10/553,832

Mario Giorgio Prussiani

Office Action Summary

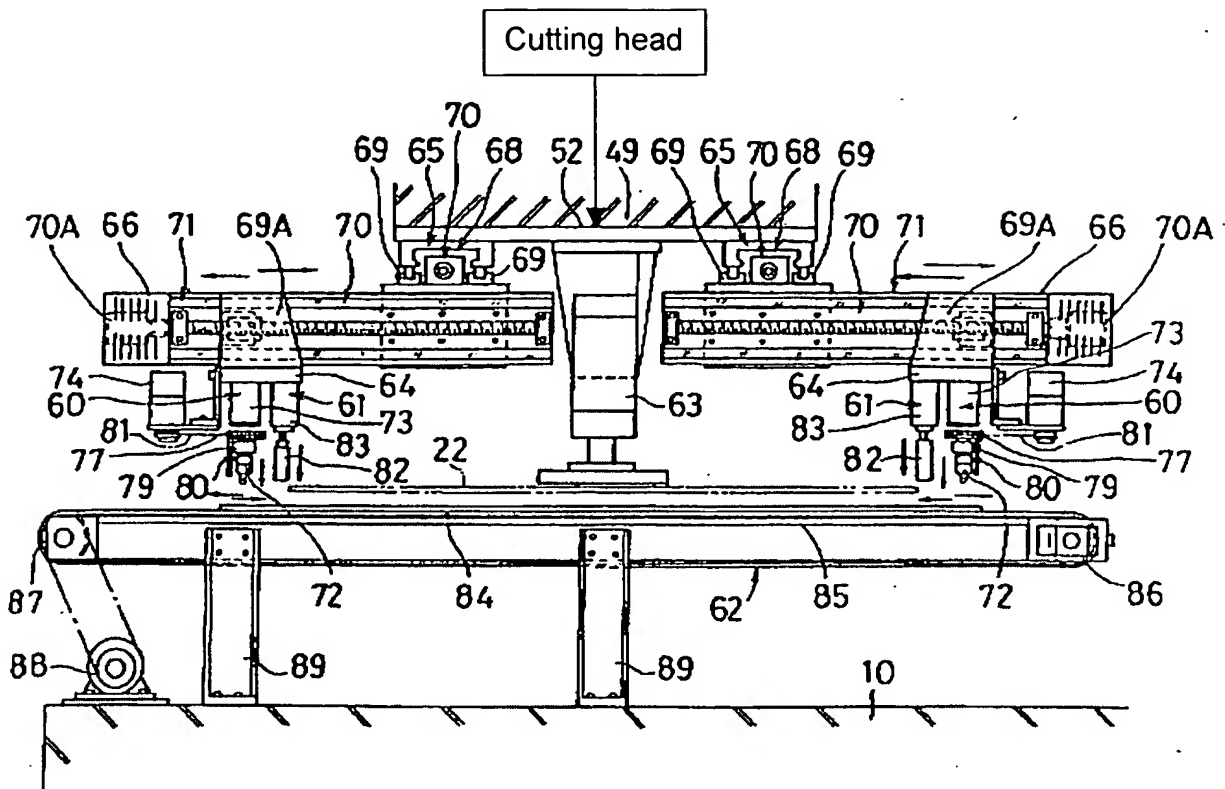
10. Claims 19- 24 are rejected under 35 U.S.C. 102(b) as being anticipates by Bando (5221034). Bando discloses a numerical control mechanism (Column 2, Lines 10-22) for controlling a cutting head (Figure 14) (see figure below) having a blade (72) addressable within a cutting volume and comprising means for manipulating workpieces (sheets) within said cutting volume, wherein said manipulating means are formed as a suction device (63) that extends from the cutting head.

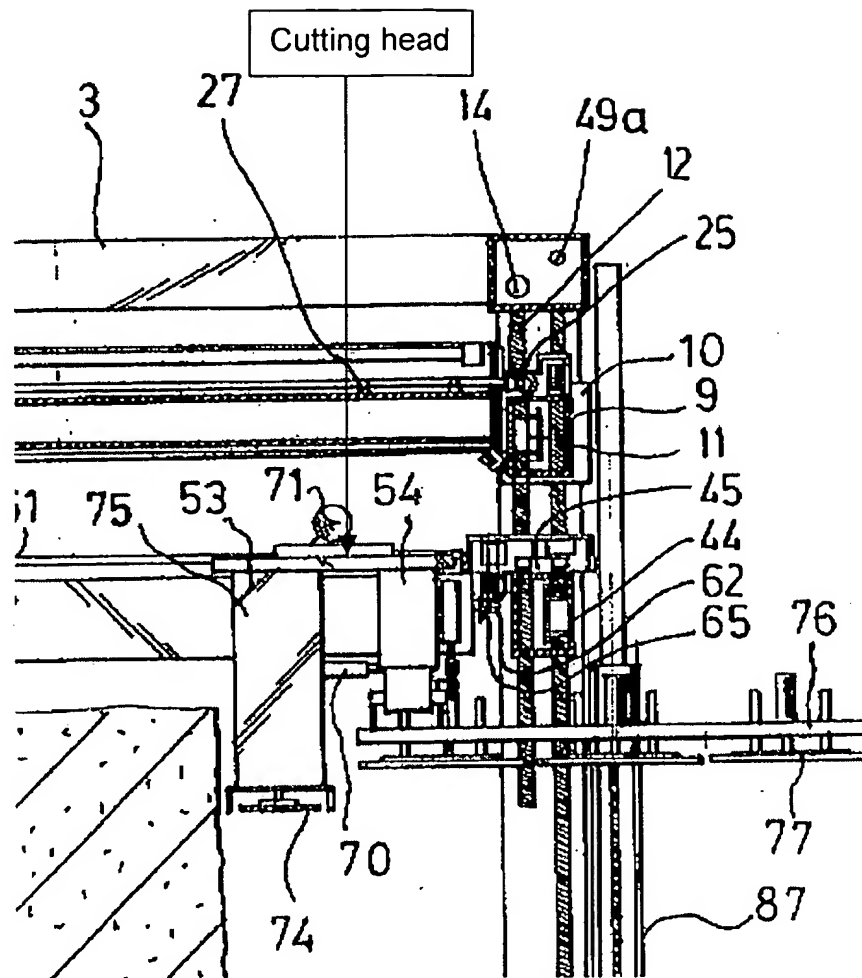
11. Claims 19-24 are rejected under 35 U.S.C. 102(b) as being anticipated by Christian (FR 2706348). Christian discloses a numerical control mechanism (see abstract) for controlling a cutting head (Figure 2) (see figure below) having a blade (74) addressable within a cutting volume and comprising means for manipulating workpieces (sheets) within said cutting volume, wherein said manipulating means are formed as a suction device (54) that extends from the cutting head.

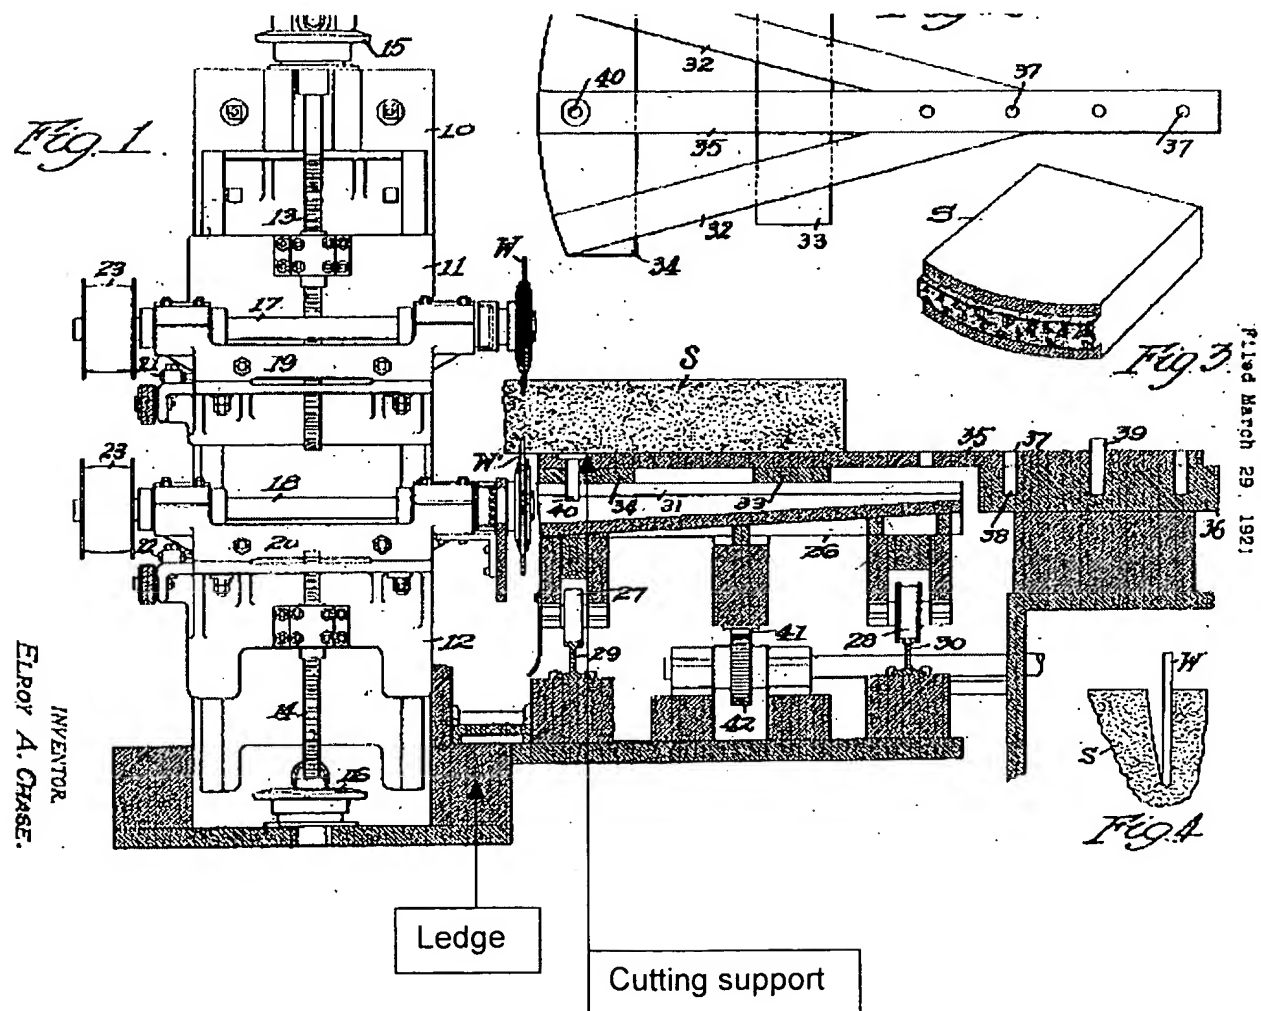
15. Claim 27, is rejected under 35 U.S.C. 103(a) as being unpatentable over Bando (5221034) in view of Chase (1509585). Bando discloses the claimed previously mentioned above, but lacks, a cutting disc disposed below the workpieces. However, Chase discloses a lower cutting disc (W') disposed below the workpiece (S). It would have been obvious to one of ordinary skill in the art at the time the invention was made to modify the device, of Bando, with lower cutting disc, in view of Chase, in order to cut different sections of a workpiece simultaneously thereby increasing production and efficiency.

17. Claims 28-32 are rejected under 35 U.S.C. 103(a) as being unpatentable over Bando (5221034) in view of Gawazawa (2003/0070520) and Chase (1509585). Bando discloses the claimed previously mentioned above, but lacks, a cutting disc disposed to a side of the cutting support. However, Chase discloses a cutting disc (W') disposed to

a side of the cutting support (See figure below). It would have been obvious to one of ordinary skill in the art at the time the invention was made to modify the device, of Bando, with lower cutting disc, in view of Chase, in order to cut different sections of a workpiece simultaneously thereby increasing productivity and efficiency.

In reference to claim 31, Chase also discloses that the vertical guides are fixed to a ledge projecting from said support (see figure above).
